Product Specification:
Engraved Nameplates - Plastic

Shop Drawing Submittal Review

Project Name: Webster University-**ISB**

Item No.	Description	No. of Copies	Date
1	Shop Drawing Review – 22 0553 Identification for Plumbing Piping and Equipment	1	02-12-2017

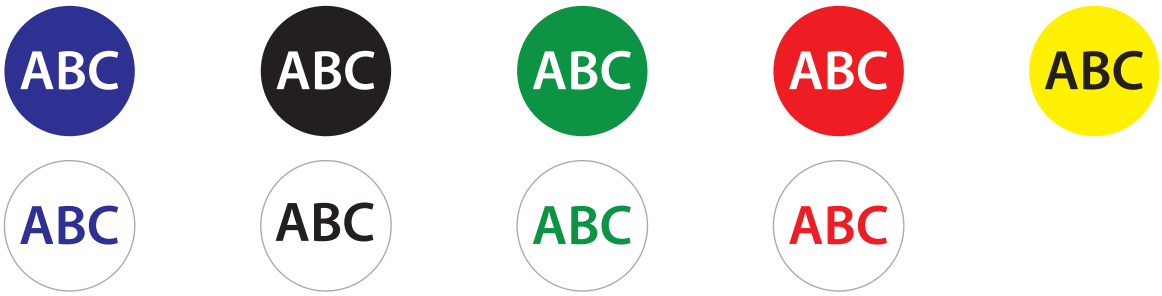
Specified to be 1/8” thick. Refer to specification section 220553, Part 2, Paragraph 2.1- line A2
